# ILT support in coherent PHYs

(in support of comments 418, 419, 546, 547, 548, 549,  
550, 551, 552, 397, 400)

Adee Ran, Cisco

Figure 178B-8—Training control state diagram

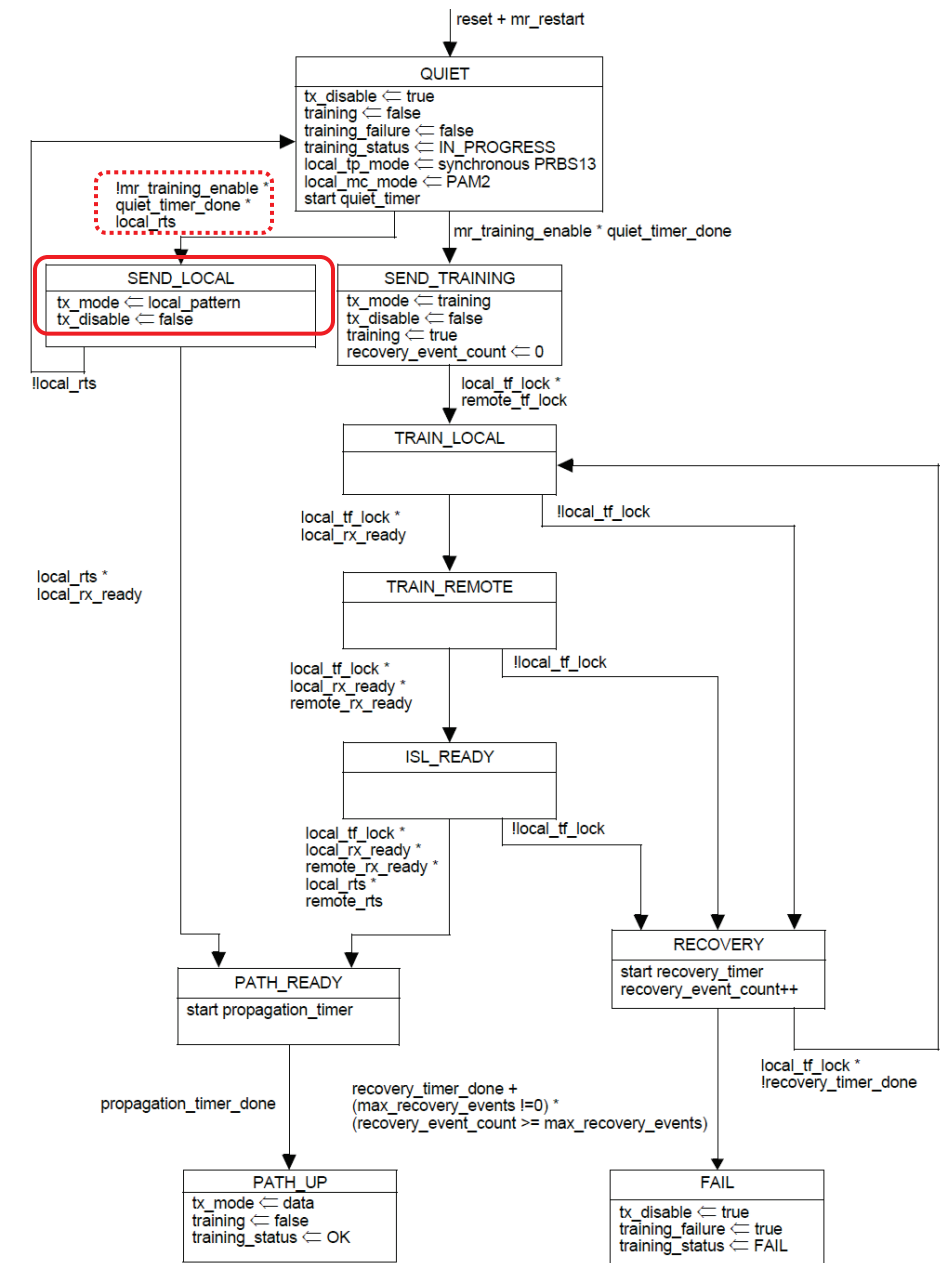
- `mr_training_enable=false` such that the left-hand part of the diagram is always used.
- While `local_rts=false`, state is QUIET
  - `tx_disable` can be implemented using the existing PMD global transmit disable function
  - Alternatively, the PMD Tx can stay on and the client (FEC) can generate another signal, e.g. unmodulated; but currently this is not defined
- When `local_rts` becomes true, it is signaled to the peer by enabling the transmitter (SEND\_LOCAL)
- When the PMD receiver is locked (`local_rx_ready`), after `propagation_timer`, the transmitter goes to DATA mode (`tx_mode=data`).
